Access Compliance Report

Public Rights-of-Way

Intersection ID: N/A	Main Street: KIRKWYND COMMONS DR	Cross Street: BRECKFIELD CT	Location: SW
ADA ID: 6BADD705BA5B	Ramp Type: PerpDiag	Initial Pass/Fail: Fail	Overall Compliance: No
Severity Score: 12.5			
Codes/Mitigation Info/Possible Solution		Field Measurements/Component Compliance

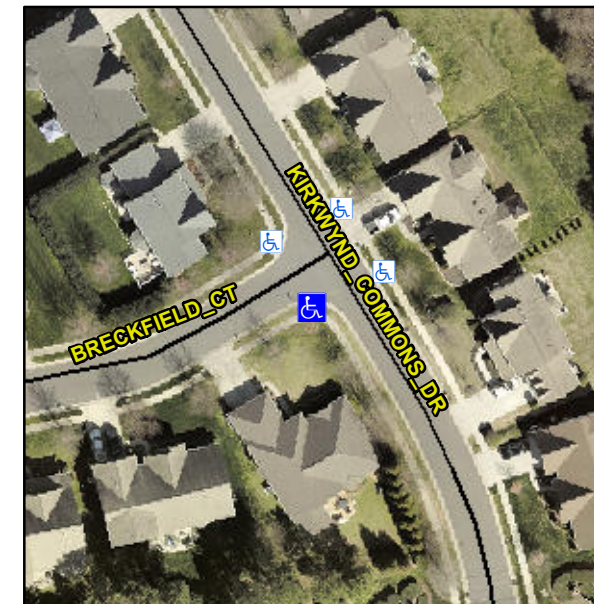
R304.2.2

Compliance	Description	Data	Compliance	Description	Data
N/A	Ramp Length (in)	47.0	No	Ramp Slope (%)	10.0
Yes	Ramp Width (in)	48.0	Yes	Ramp XSlope (%)	1.8
N/A	Flare Type LT	N/A	N/A	Flare Type RT	N/A
N/A	Flare Slope LT (%)	N/A	N/A	Flare Slope RT (%)	N/A
N/A	Flare Traversable LT?	N/A	N/A	Flare Traversable RT?	N/A
N/A	Landing Length (in)	N/A	N/A	DWS Provided?	N/A
N/A	Landing Width (in)	N/A	N/A	DWS Contrast?	N/A
N/A	Landing Slope (%)	N/A	N/A	DWS Length (in)	N/A
N/A	Landing X Slope (%)	N/A	N/A	DWS Full Width?	N/A
N/A	Landing Curb? (Y/N)	N/A	N/A	DWS Offset (in)	N/A
N/A	Shared Landing?	N/A			
N/A	Gutter Ponding?	N/A	N/A	Gutter Slope (%)	N/A
N/A	Gutter Lip Ht (in)	N/A	N/A	Gutter X Slope (%)	N/A
N/A	Painted X Walk1?	No	N/A	Painted X Walk2?	No
	X Walk 1 Direction	To NE		X Walk 2 Direction	To NW
N/A	X Walk 1 Width (in)	N/A	N/A	X Walk 2 Width (in)	N/A
	X Walk 1 Slope (%)	0.9		X Walk 2 Slope (%)	2.9
	X Walk 1 X Slope (%)	2.0		X Walk 2 X Slope (%)	0.8

Remove & Replace Curb Ramp With Two New Directional Ramps or Equivalent.
